CITY OF OREGON CITY HISTORIC REVIEW BOARD AGENDA

Virtual Meeting
Tuesday, May 25, 2021 at 7:00 PM

GLUA-20-00022 and HR 20-10: Historic Review for alterations to a contributing structure in the Canemah National Register District at 112 Miller St.

**Historic Review
Staff Report and Recommendation
May 18, 2021**

GLUA-21-00022 112 Miller

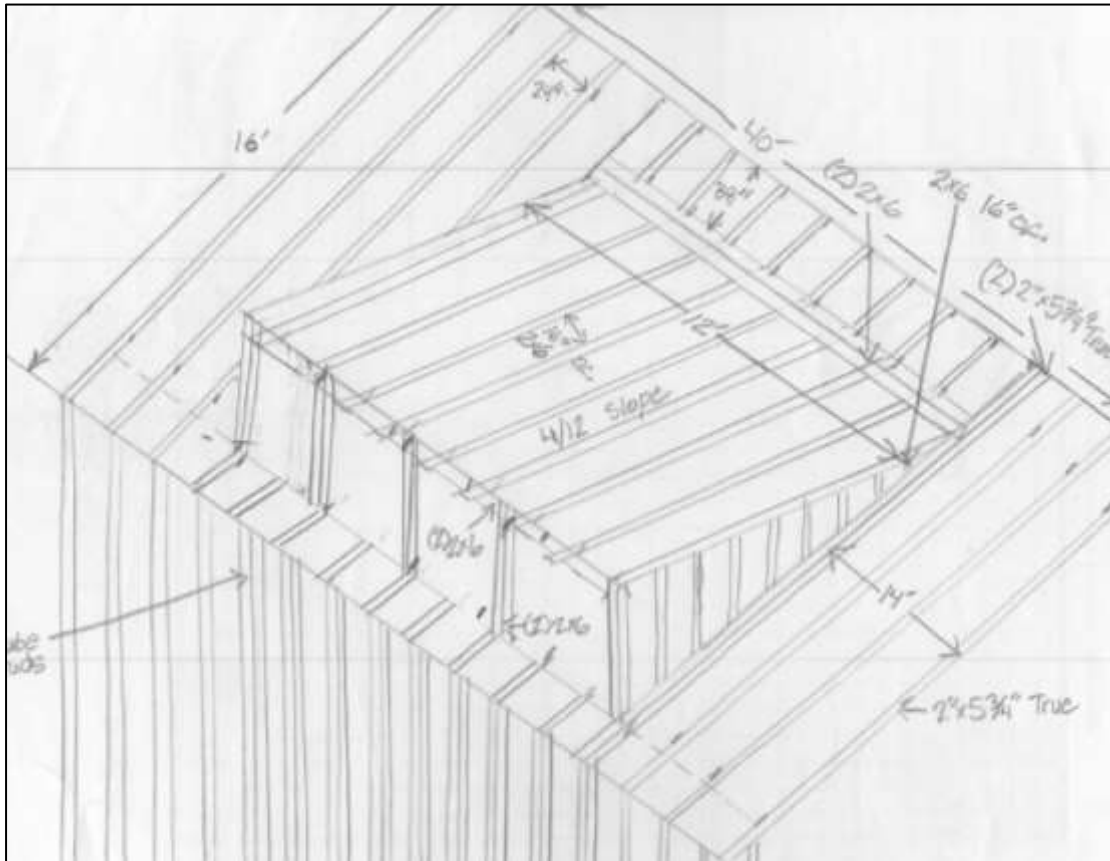
The applicant proposes to add a shed dormer on the north side of the home. While dormers are more typically on the front of a bungalow, the side dormer may be found to be appropriate. The applicant notes that upon a roof repair, evidence of a dormer was found on the north side of the roof, so it is possible that there was a dormer there in the past, although no historic photos are available. Shed dormers are common on bungalows, and gable dormers are sometimes used as well. The roof slope is

likely a 6:12 on the main house. The proposed dormer has a 4:12 slope and is placed centrally along the 40-foot side of the home, which will provide balance. The size of the dormer is 12 feet wide, compared to a roof plane of 36 to 40 feet in length; it is proportionally sized. It is proposed to be setback from the front edge of the roofline is 16 feet, which will also reduce the impact of its appearance. The proposed four windows of 2:1 proportion in the dormer are also appropriately sized.

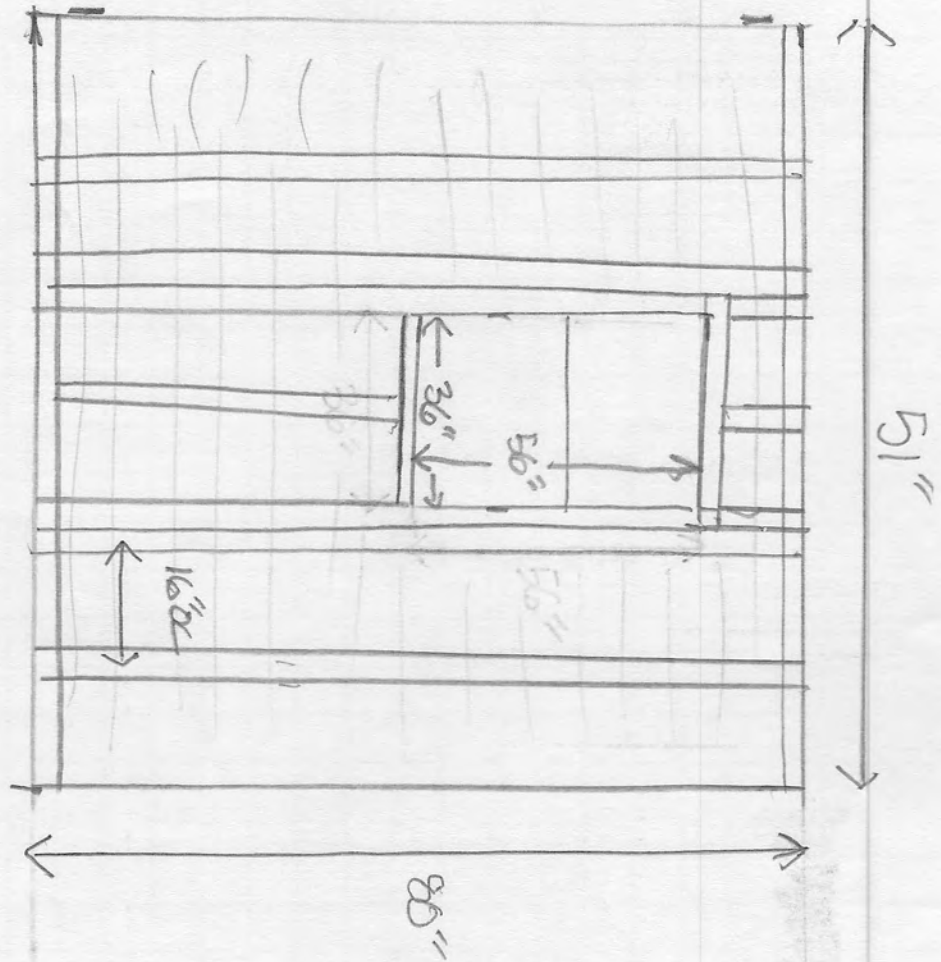
front bedroom window to match
back bedroom as when house
built without
porch bumpout.

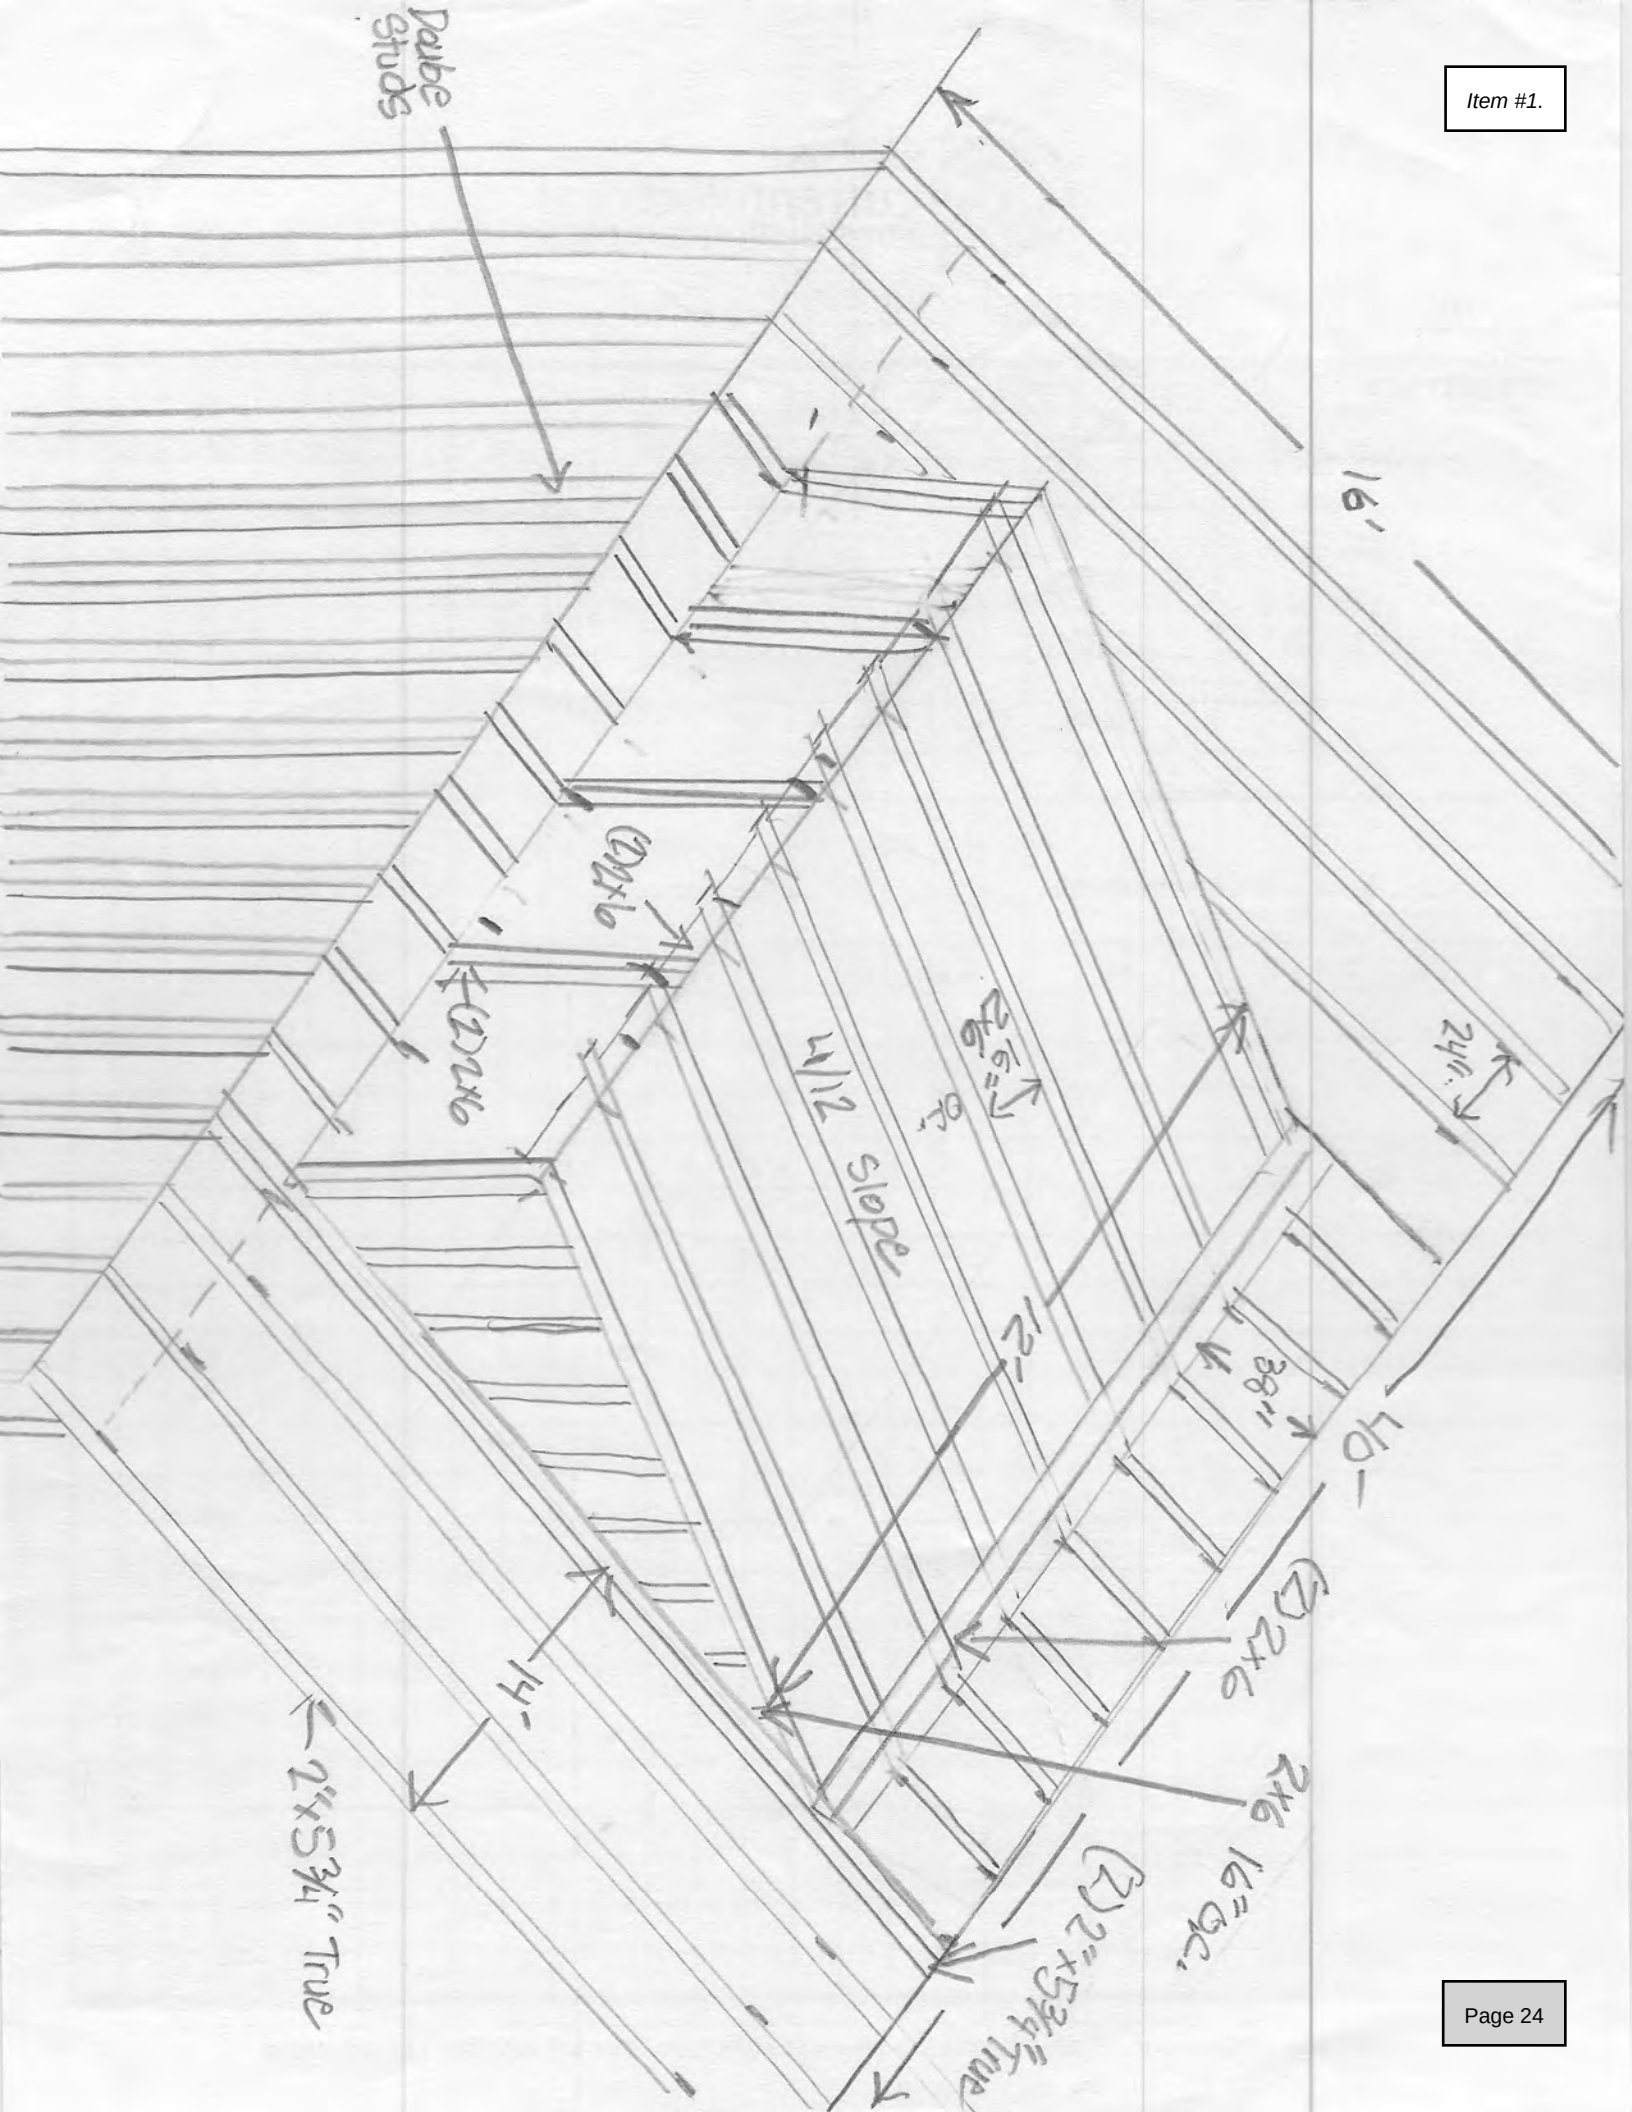
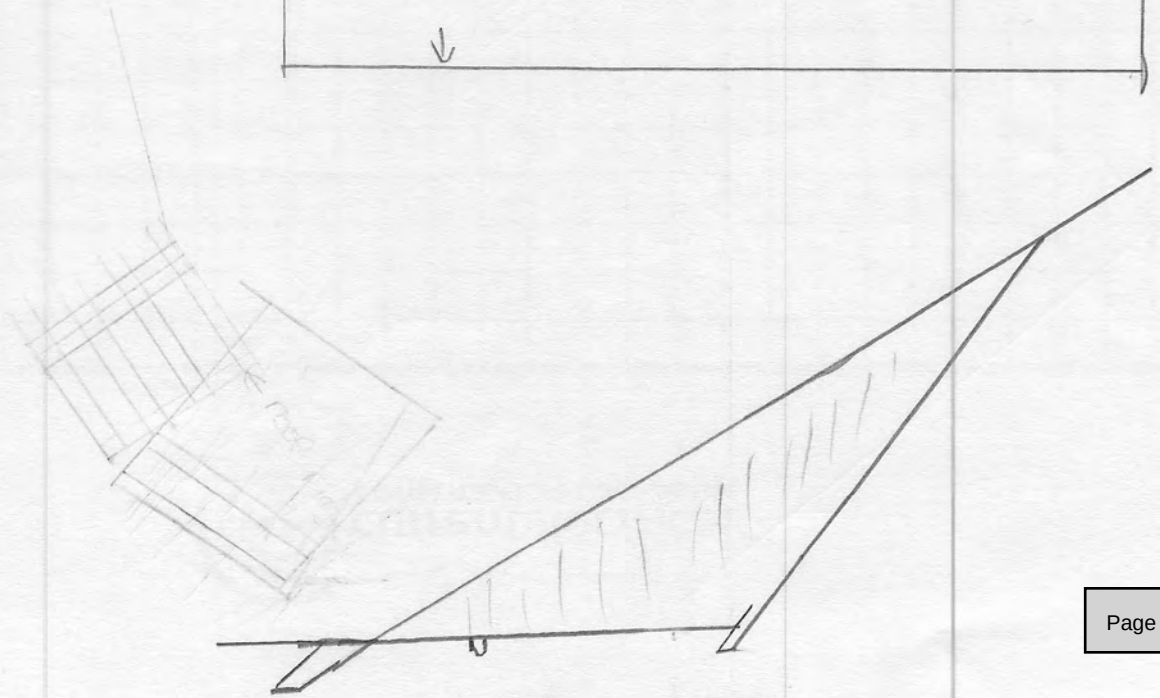
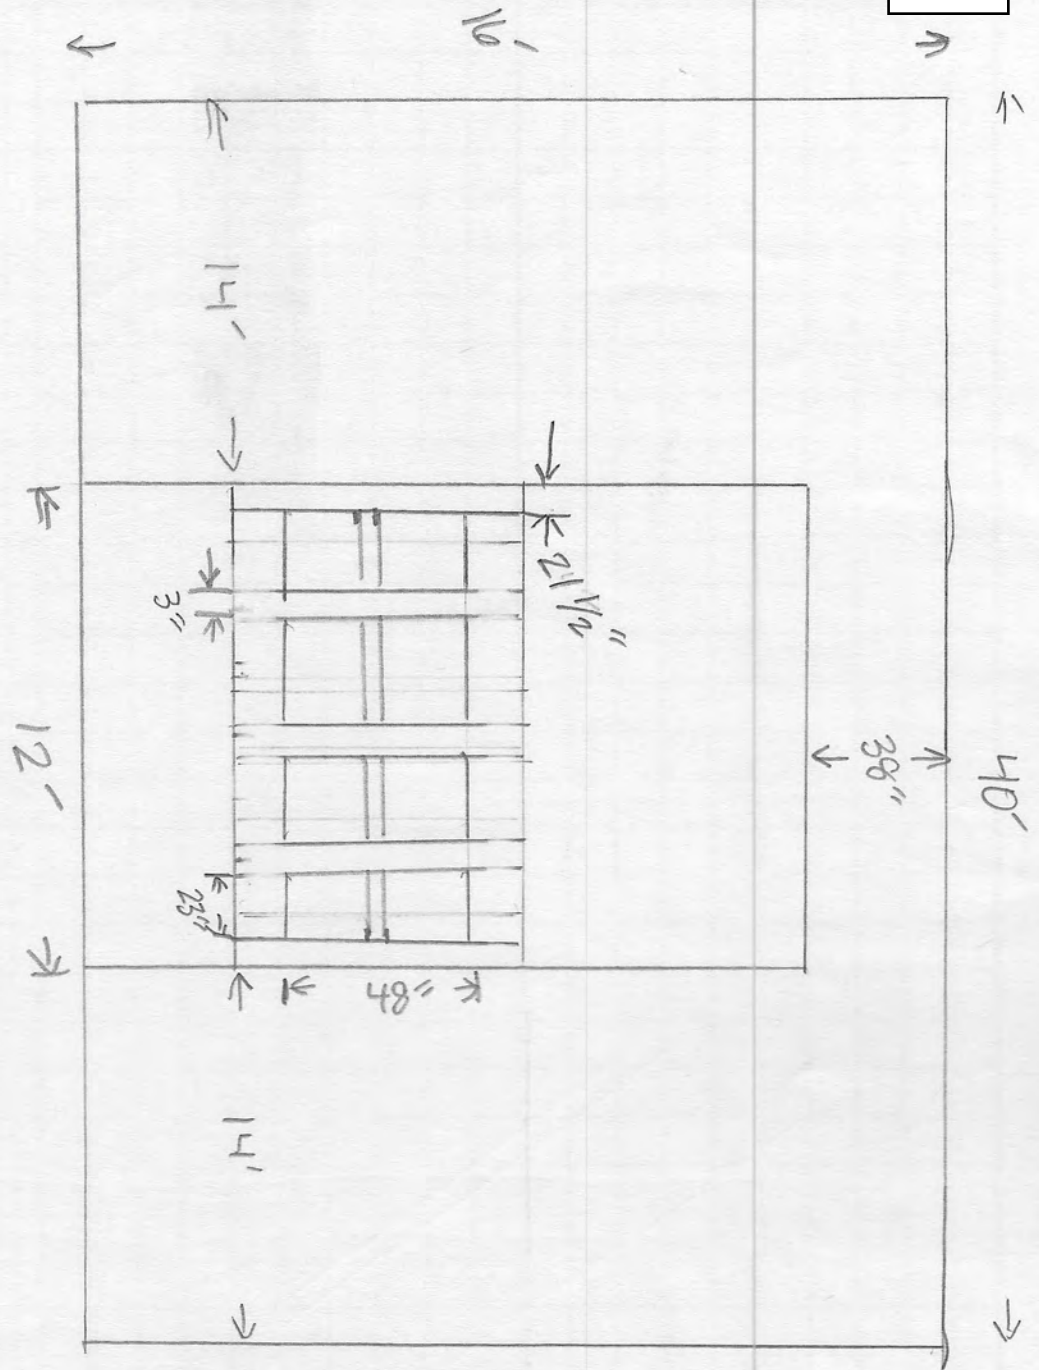
- Non-Structural wall
- All 2x6 to match wall
- Window to match 2nd bedroom window
- Siding to match original on house.

Proposed Site Plan

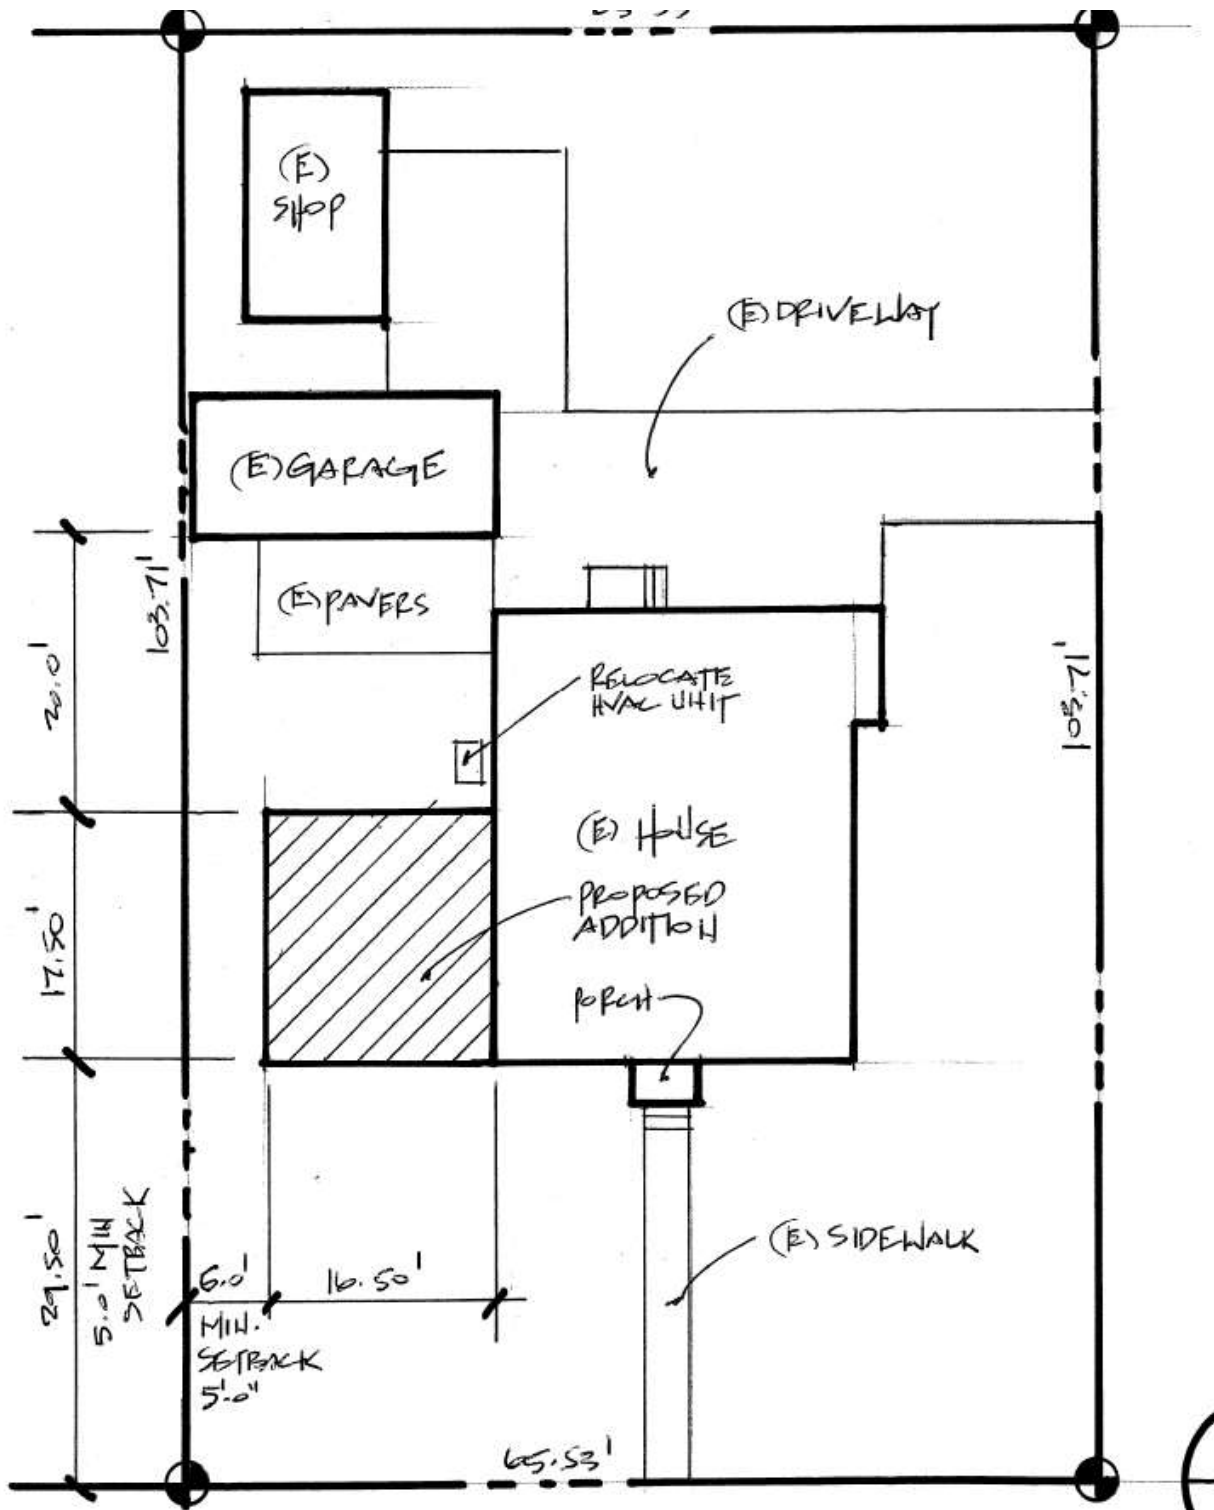
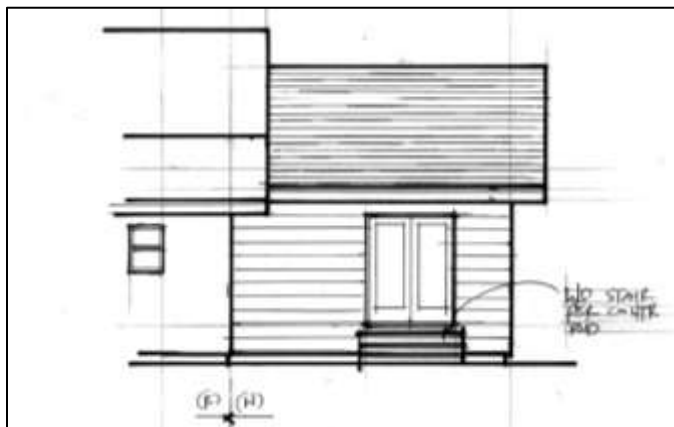
The applicant proposes vinyl windows to match the existing windows on the home. The owner would like to move the existing window on the side of the house to the front (facade) of the addition so that they all match if possible. If differentiation is needed, different window material could help to provide

Also, vinyl windows are typically not permitted but fiberglass would probably work fine. If you could provide more details about the windows (brand and type) before the hearing, that might be helpful.

As for the windows, we have not chosen anything yet fiberglass or vinyl, but we are not picky. The window on the side of the house where the addition is going is vinyl, along with the rest of the house. I mentioned the last time that we spoke that I would like to move that window to the front (facade) of the addition so that they all match if possible.
